Our Case Number: ABP-314724-22

Re: Railway (Metrolink - Estuary to Charlemont via Dublin Airport) Order [2022]
Metrolink. Estuary through Swords, Dublin Airport, Ballymun, Glasnevin and City Centre to
Charlemont, Co. Dublin

Observation on a Strategic Infrastructure Development Application

Location: Mater Station

Figure 3 View of Mater Station location from Berkeley Road

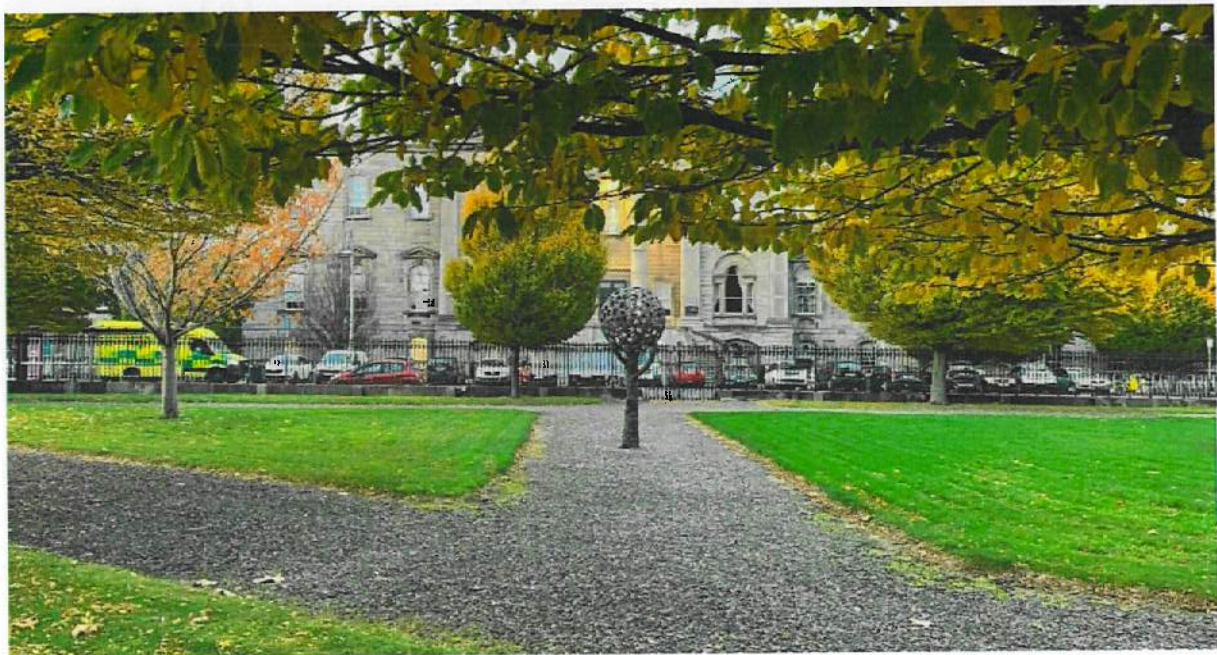
The EIAR explicitly states at 4.9.23 that "The station facilities at ground level will be integrated with the existing urban environment." As can be seen from the photomontages provided on the Railway Order application, this is not the case. The Mater station and associated infrastructure is obtrusive and unsympathetic to the Architectural Conservation Area within which it is sited.

The design of the proposed development is entirely out of character with the general appearance and character of the existing Victorian streetscape and the façade of the Mater Hospital. The industrial design and materials proposed are quite different to the surrounding buildings. The station and various associated work are extremely visually intrusive and will be the dominant feature of the Eccles Street/Berkley Road intersection. It will irreversibly affect a unique and beautiful streetscape.

This is contrary to good planning as identified in the EIAR itself, while the impact on residents in 18-22 Berkeley Road is especially pronounced as the station is just a few metres away and positioned in the direct line of front windows, thus having an extremely negative impact on the visual amenity of the area and house.

- a) A station design that is more visually appropriate for a metro station in a small urban park surrounded by Victorian buildings. There are numerous examples of station design that are much less obtrusive than what is proposed and more in keeping with what residents understood to be an “underground station”.
- b) Relocating the station entrance further into the park so it is less disruptive and respects sight lines/views along Berkeley Road
- c) Minimising above ground station infrastructure by removing the ‘light wells’ which will allow more green space, and using artificial light in the station;
- d) A requirement to plant equivalent mature trees to those that will be cut down as part of the construction process in order to soften the impact of the station.
- e) Removal of crossing outside no. 21 Berkeley Road or mitigations sufficient to address noise pollution concerns
